1. CHANGER DESCRIPTION

(3) FOLDER LCD

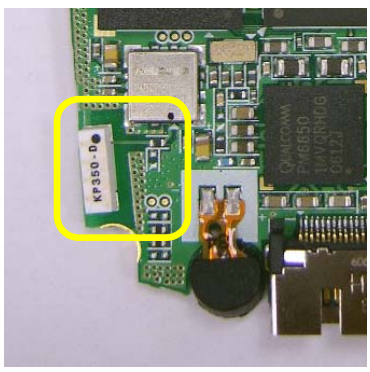
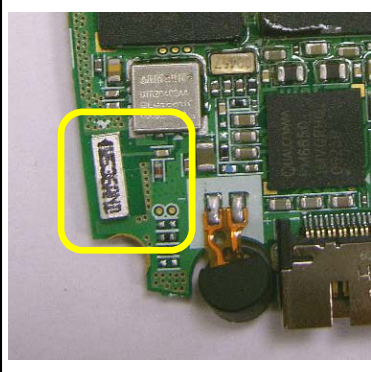
Previous version	New version	Remark
		1. Added one Rubber 2. Added two ESD tape on LCD module 3. Added one insulation tape on LCD module
